Access Compliance Report Public Rights-of-Way (Curb Ramps)

Main Street: BANBURY_CROSS_RD Cross Street: ARROYO_AVE Location: S

ADA ID: RPRK211012132326 Ramp Type: Type 6 - Directional 1 Initial Pass/Fail: Pass Overall Compliance: No Severity Score: 5

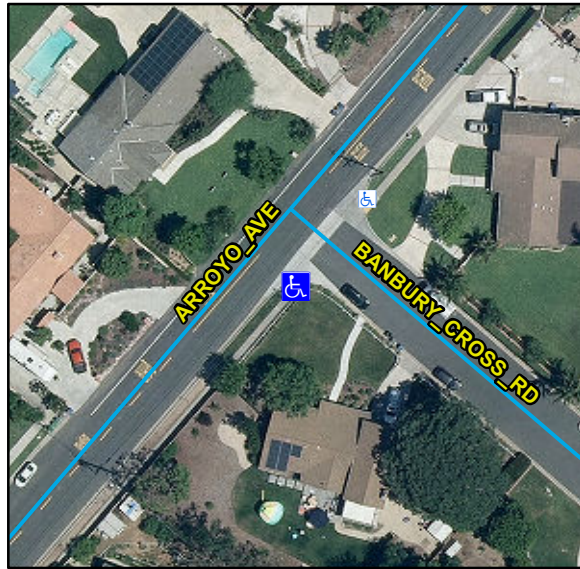
R304.2.2, R304.5.3, R304.5.4, STD 1115

Remove & Replace Entire Ramp. Remove & Replace Gutter.
